ND-13-0494
10 CFR 50.90
10 CFR 52.63

Southern Nuclear Operating Company
Vogtle Electric Generating Plant Units 3 and 4
Request for License Amendment and Exemption:
Turbine Building Battery Room and Electrical Changes (LAR-13-007)

**Turbine Building Battery Room and Electrical Changes
(LAR-13-007)**

Figure 8.3.2-3 (Sheet 1 of 3)
Non-Class 1E DC & UPS System One Line Diagram

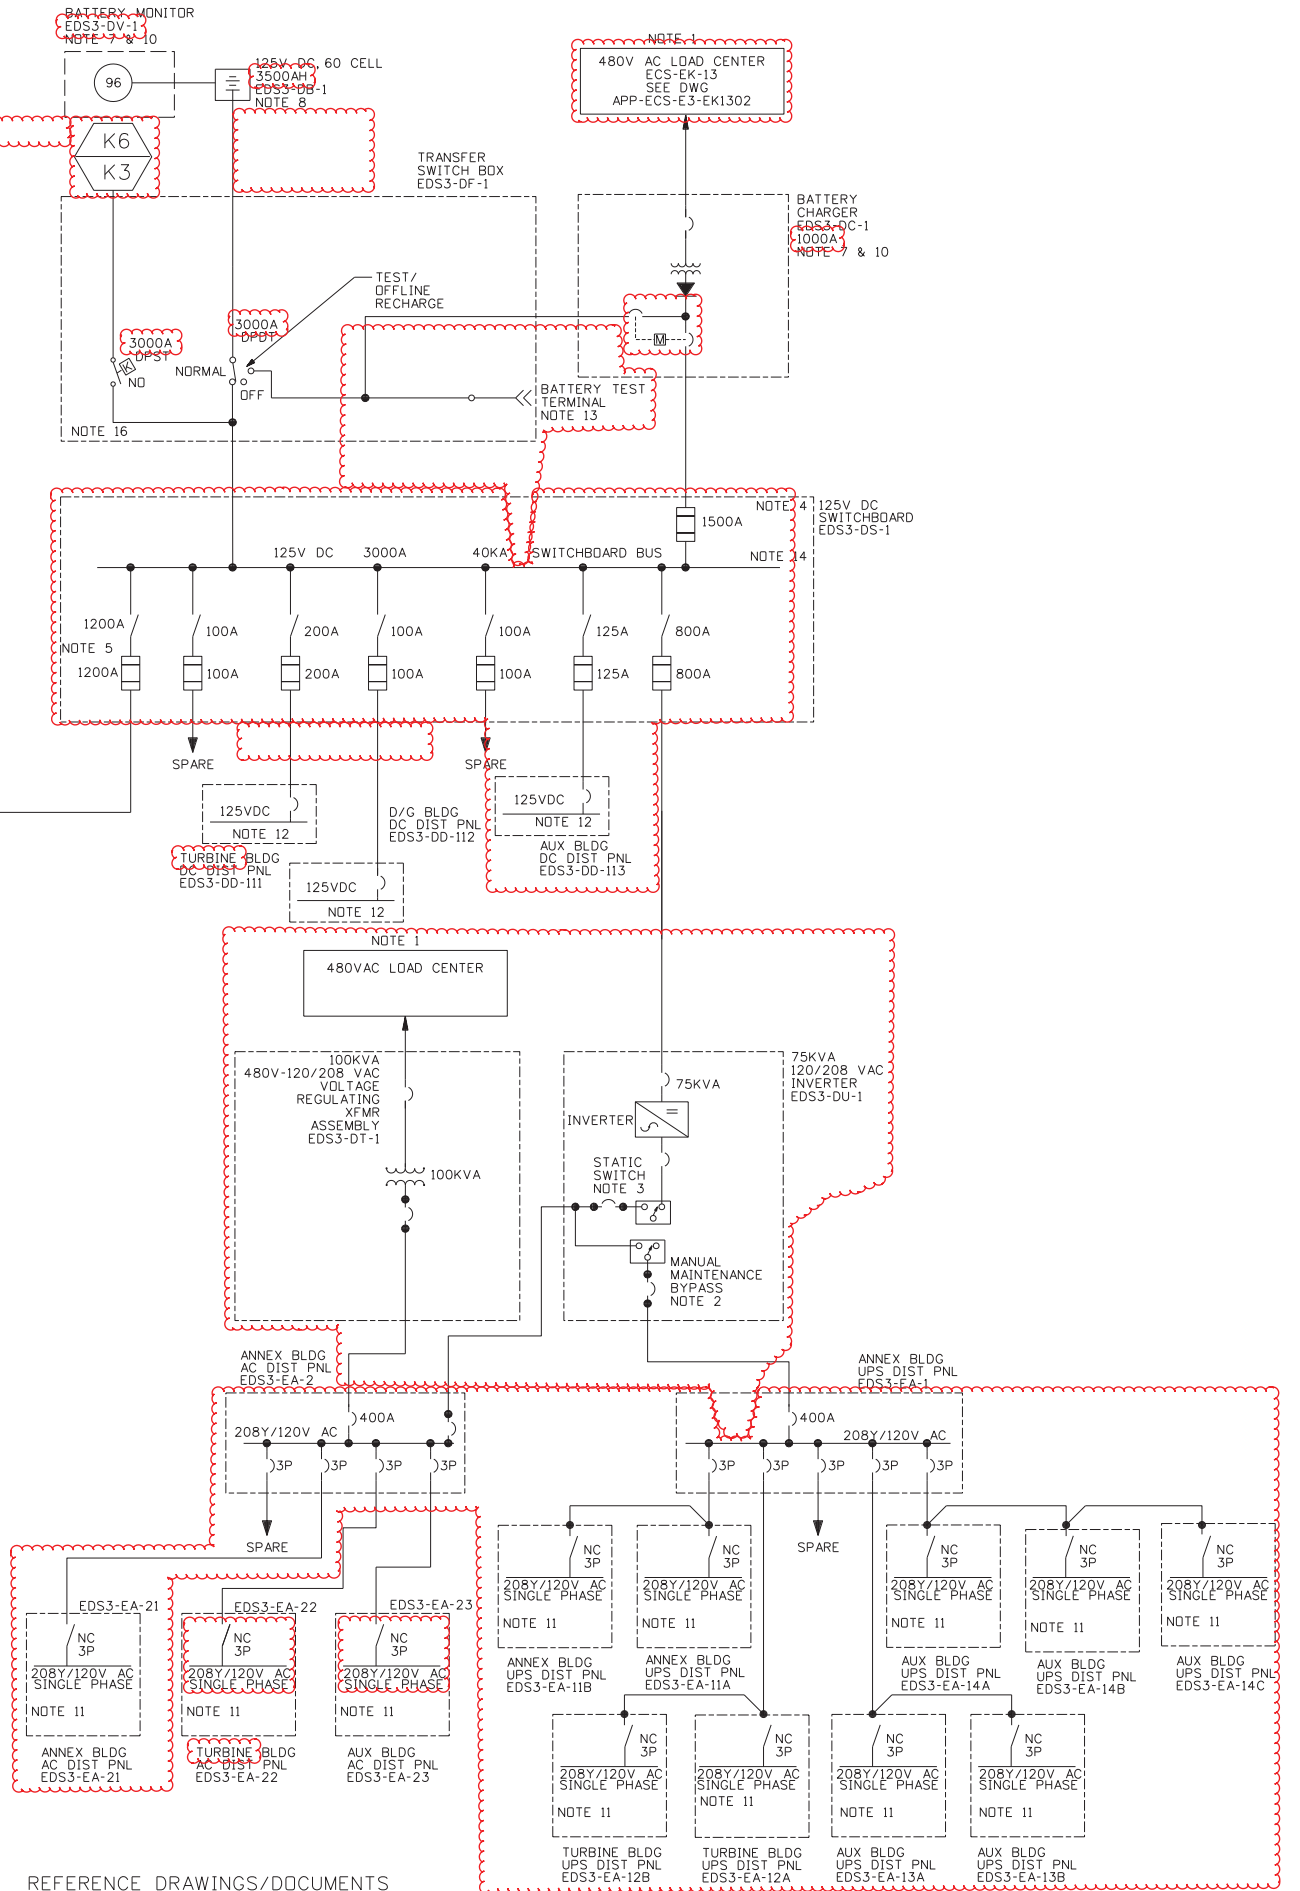
UFSAR Figure 8.3.2-3 (Sh 1)	Delete the existing EDS spare charger (EDSS-DC-1)
UFSAR Subsections 8.3.2.5.10, 8.3.2.5.11, and 8.3.2.5.12	Increase each EDS battery charger output current testing load from 550 amps to 900 amps, increase each EDS battery testing load from 500 amps to 850 amps, and increase each inverter testing resistive load from 35 kW to 55 kW
UFSAR Tables 8.3.1-1 (Sh 3, 4, & 5), 8.3.1-2 (Sh 3 & 4), and 8.3.2-6 (Sh 1, 2, & new 3).	Revise to reflect component electrical parameter nominal value changes and the addition of spare component values
UFSAR Subsection 14.2.9.2.16	Revised to clarify the capabilities of each EDS battery and charger to serve defense-in-depth loads

Along with the proposed capacity increases, there are proposed EDS configuration optimization changes that eliminate the EDS (1, 2, 3, and 4)-DS-11 switchboards, combining them into the EDS (1, 2, 3, and 4)-DS-1 switchboards, respectively. There is sufficient switchboard space to contain the consolidated equipment in a single switchboard per subsystem, and still meet the applicable requirements for each subsystem. Also, there is a proposed change for the deletion of the stand-alone spare EDS charger (EDSS-DC-1), which is not necessary because of the addition of the new EDS spare battery, chargers, and fused transfer switch box.
